Georges River Local Planning Panel

Thursday, 21 August 2025

REPORTS AND LPP DELIBERATIONS**REPORT TO GEORGES RIVER LOCAL PLANNING PANEL MEETING OF THURSDAY, 21 AUGUST 2025****LPP022-25 28 CARLTON CRESCENT, KOGARAH BAY****LPP022-25**

LPP Report No	LPP022-25	Development Application No	DA2023/0025
Site Address & Ward Locality	28 Carlton Crescent, Kogarah Bay Kogarah Bay Ward		
Proposed Development	Subdivision, demolition works and construction of a dwelling house, outbuildings and ancillary works.		
Owners	Mona Kayrouz		
Applicant	Glenn McCormack		
Planner/Architect	Glenn McCormack, Design Practitioner		
Date Of Lodgement	21/03/2023		
Submissions	3		
Cost of Works	\$1344712.00		
Local Planning Panel Criteria	Works to a heritage item		
List of all relevant s.4.15 matters (formerly s79C(1)(a))	State Environmental Planning Policy (Resilience and Hazards) 2021, State Environmental Planning Policy (Biodiversity and Conservation) 2021, State Environmental Planning Policy (Sustainable Buildings) 2022, Georges River Local Environmental Plan 2021 (GRLEP 2021), Georges River Development Control Plan 2021 (GRDCP 2021)		
List all documents submitted with this report for the Panel's considerati

Clause 6.4 – Foreshore area and coastal hazards and risk

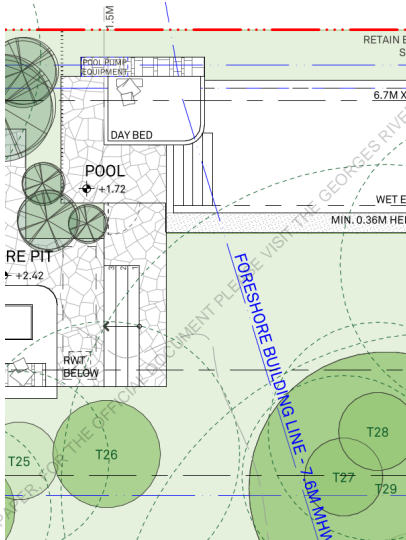
<p>(b) land identified on the Foreshore Building Line Map.</p> <p>(3) Development consent must not be granted for development on land to which this clause applies except for the following purposes—</p> <p>(a) the alteration, or demolition and rebuilding, of an existing building if the footprint of the building will not extend further forward than the footprint of the existing building into—the foreshore building line, or the land identified on the Coastal Hazard and Risk Map,</p> <p>(b) the erection of a building if the levels, depth or other exceptional features of the site make it appropriate to do so,</p> <p>(c) boat sheds, cycling paths, fences, sea walls, swimming pools, water recreation structures or walking tracks.</p> <p>(4) In deciding whether to grant development consent, the consent authority must consider the following matters—</p> <p>(a) whether the development addresses the impacts of sea level rise and tidal inundation as a result of climate change,</p> <p>(b) whether the development could be located on parts of the site not exposed to coastal hazards,</p> <p>(c) whether the development will cause congestion or generate conflict between people using open space areas or the waterway,</p> <p>(d) whether the development will cause environmental harm by pollution or siltation of the waterway,</p> <p>(e) opportunities to provide reasonable, continuous public access along the foreshore, considering the needs of property owners,</p>	<p>A swimming pool has been proposed within the foreshore building line which satisfies the clause.</p> <p>A structure “Day bed” located near the FBL and encroached the FBL. The applicant did not submit clause 4.6 regarding this encroachment.</p>  <p>The proposal does not have opportunities to provide reasonable, continuous public access along the foreshore, considering the needs of property owners.</p> <p>The subject site is restricted by the FBL. Per Clause 6.4(3) of the GRLEP 2021, new dwelling house shall not be located forward of the FBL. The building footprint of the dwelling house depends on the location of the FBL.</p> <p>A Structure “Day bed” encroached the FBL.</p>

Figure 07: Excavation (Source, Applicant's SEE)

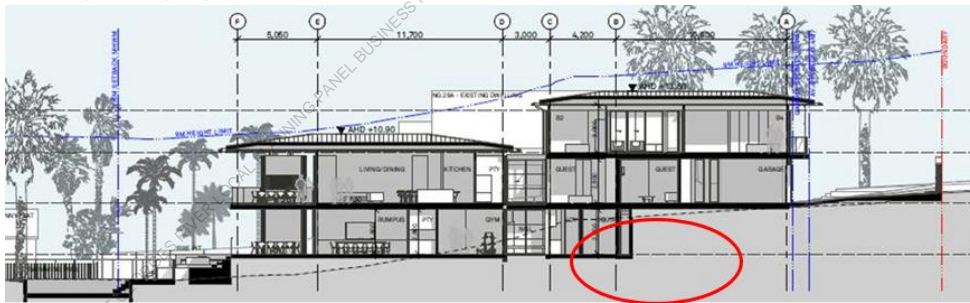
- Under Part 3.5.1 of GRCP 2021, cut and fill for any proposed development are not to alter natural ground levels by **more than 1m**. In addition, the GRDCP 2021 also requires **habitable rooms to be located above existing ground level. The proposed development proposes 2.54m excavation which is excessive.**

Figure 8: Extent of proposed variation. The red line represents the maximum building height of 21m.

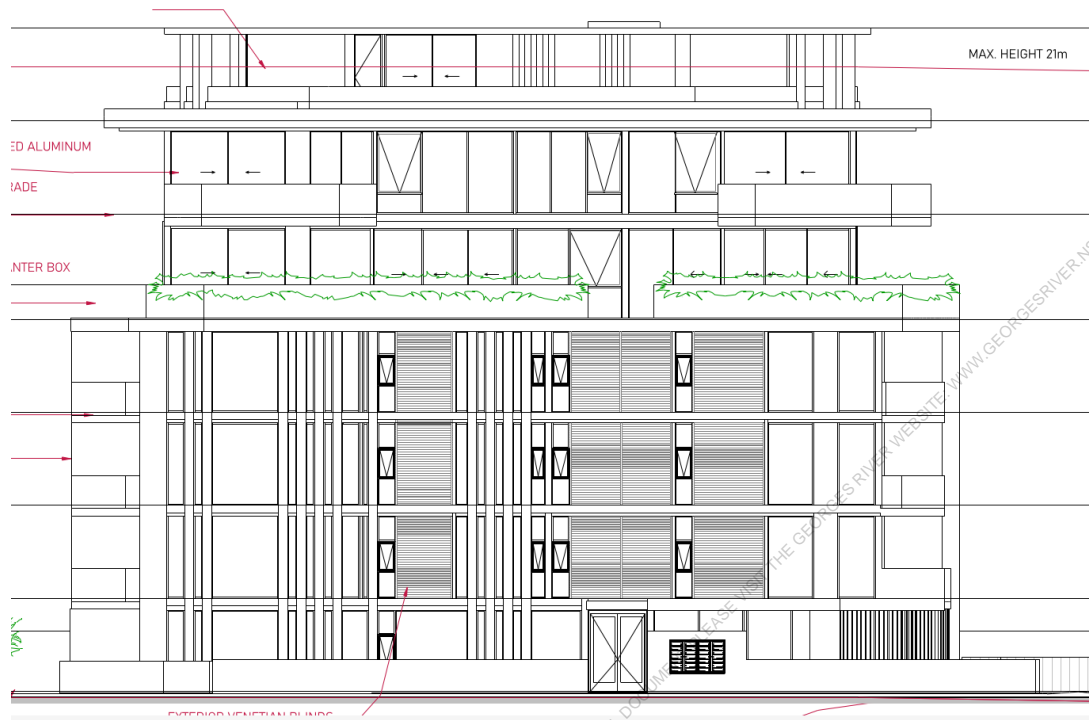
The extent of the proposed variation is indicated below:
